# Tech Tip

## October 2023

## TAMX- Sensor Wire Color Changes

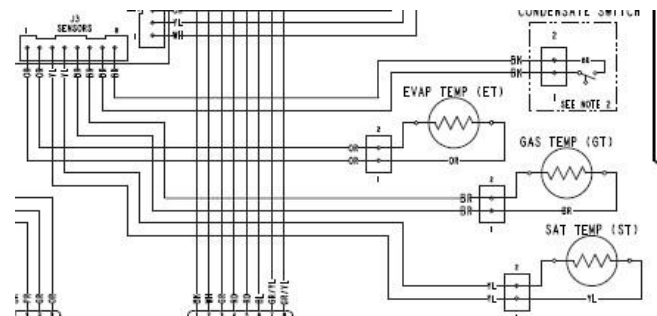
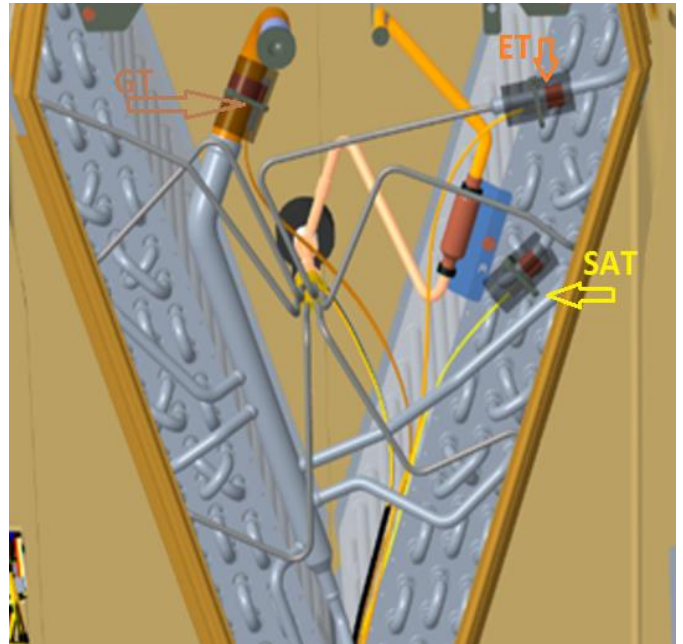
After years of becoming used to Hyperion air handlers having the same color sensor leads, the newest TAMX version has a big change.

The Gas Temp (GT) sensor is no longer black but now **brown**.

The Evap Temp (ET/Coil) sensor has gone from yellow to **orange**.

And a new Saturation (SAT) sensor is **yellow**. *Bonus tip: This sensor does nothing currently and does not affect the operational logic of the EEV process. If it fails however, an alert will be generated.*

This can cause some confusion as we're accustomed to yellow being the ET/Coil sensor. We have had some reports of the ET and SAT sensors getting reversed. Think about what that would do. With the ET sensor at the warmer SAT location, the EVC would see lower superheat and command the EEV to a smaller position, attempting to build superheat. You would then see a lower suction pressure and a higher superheat.
